Technical Service Information

THM 440-T4 HARSH 3-2 DOWN SHIFT

Figure 1

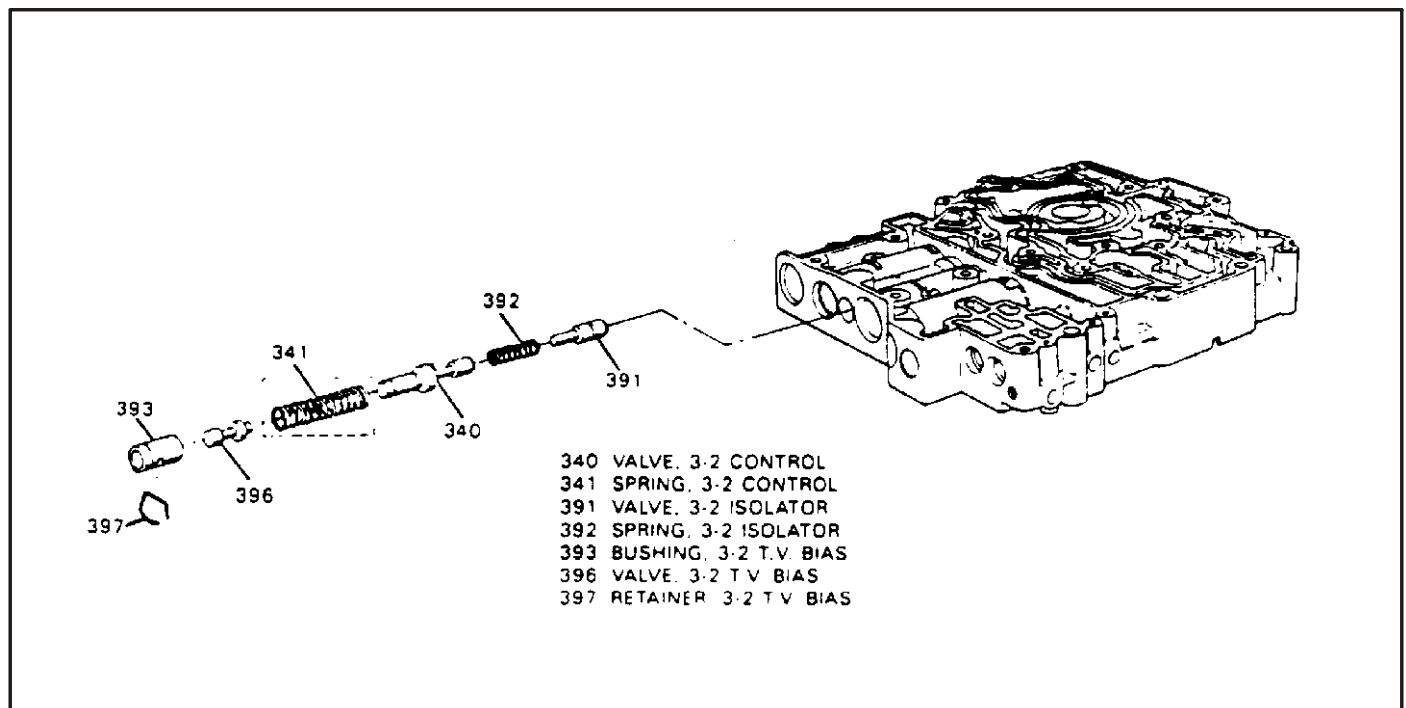
COMPLAINT: Harsh 3-2 part throttle, or full throttle downshift

CAUSE: Improper timing for release of the third clutch and reapplication of the 1-2 band.

CORRECTION: Install a new 3-2 Control Valve Spring, now available in a service package from OEM. See "Service Information" in this bulletin for proper part numbers, and refer to Figure 1 for installation
